Access Compliance Report Public Rights-of-Way (Curb Ramps)

Main Street: SIENNA_PKWY Cross Street: O_NEILL_DR Location: NE

ADA ID: RPRK211111130949 Ramp Type: Type 1 - Perpendicular Initial Pass/Fail: Pass Overall Compliance: No Severity Score: 25

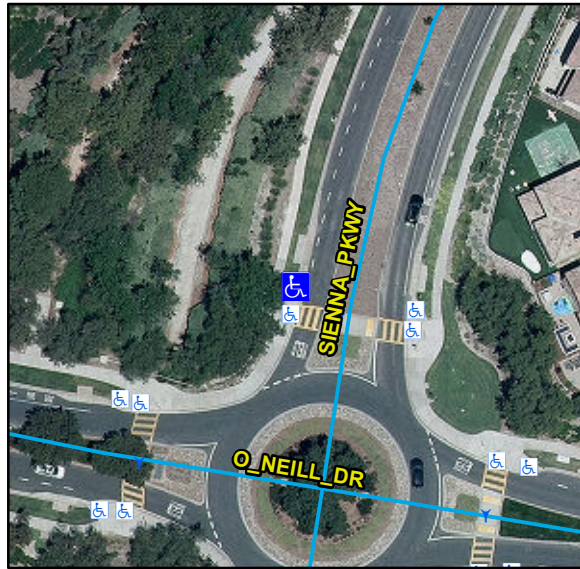
Compliance	Description	Data	Compliance	Description	Data
N/A	Ramp Length (in)	120	No	Flare Type LT	
Yes	Ramp Width (in)	52			Curbed1
Yes	Ramp Run Slope (%)	7.7	N/A	Flare Slope LT (%)	N/A
Yes	Ramp Cross Slope (%)	0.5	N/A	Flare Traversable LT	N/A
N/A	Landing Present	No	Yes	Flare Type RT	
N/A	Landing Length (in)	N/A			Curbed2
No	Landing Width (in)	N/A	N/A	Flare Slope RT (%)	N/A
No	Landing Run Slope (%)	N/A	N/A	Flare Traversable RT	N/A
No	Landing Cross Slope (%)	N/A	No	DWS Provided	No
N/A	Landing Movement Obstructed?	No	N/A	DWS Contrast	N/A
	Landing Movement Type	N/A	N/A	DWS Length (in)	N/A
N/A	Landing Shared	N/A	N/A	DWS Full Width	N/A
N/A	Clear Space	N/A	N/A	DWS Offset Left (in)	N/A
N/A	Clear Space To Crosswalk (in)	N/A	N/A	DWS Offset Right (in)	N/A
N/A	Marked Crosswalk 1	No	N/A	Marked Crosswalk 2	N/A
	Crossing 1 Direction	NE		Crossing 2 Direction	N/A
	Marked Crosswalk 1 Width (in)	N/A		Marked Crosswalk 2 Width (in)	N/A

N/A	Ramp Inside Crosswalk 1	N/A	Yes	Ramp Inside Crosswalk 2	N/A
	Crossing 1 Slope (%)	1.9		Crossing 2 Slope (%)	N/A
	Crossing 1 Cross Slope (%)	2.7		Crossing 2 Cross Slope (%)	N/A
Yes	Gutter Ponding	No	No	Curb Slope	10
Yes	Gutter Lip Height (in)	0		Road Run Slope (%)	N/A
No	Gutter Run Slope (%)	12.6		Road Cross Slope (%)	N/A
No	Gutter Cross Slope (%)	3.9			
Yes	Overall Surface Condition: Acceptable		Yes	Perp Joint Present	Yes
	Cross Gutter Present?	No		Spandrel Present?	No
	Replace Cross Gutter?	N/A		Replace Spandrel?	N/A

Remove & Replace Entire Ramp. Remove & Replace Gutter.
